Product Change Notice (PCN)

PCN Number: PCN-0462303R-01

Product(s) Affected: TB003V-500 Series. Inclusive of both screw types and colors.

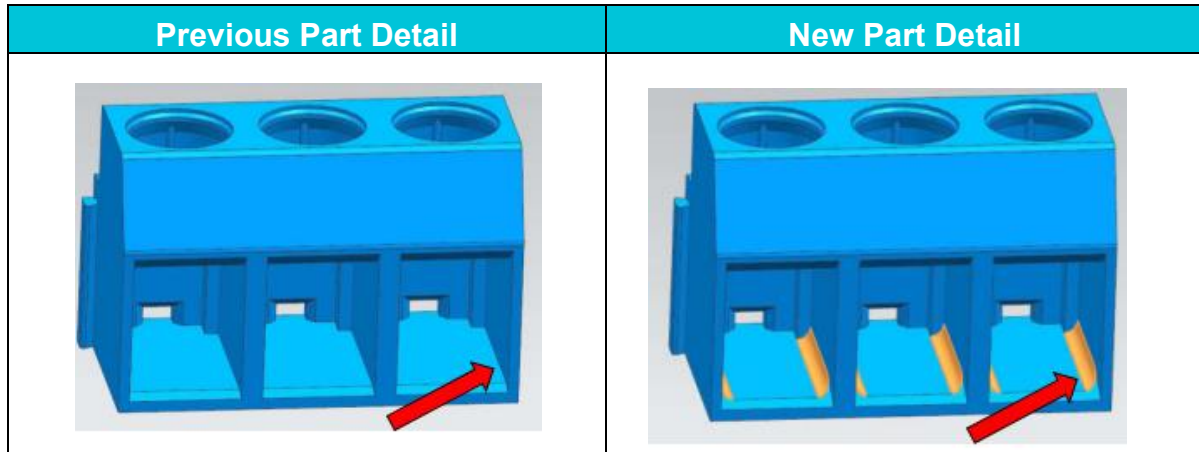
Reason(s) for Change: **Improve structural strength**

Description of Change: *Modified Housing. Add a 0.5mm thickness chamfer on the place which is right angle chamfer in the lower corners, as indicated in orange on the image below.*
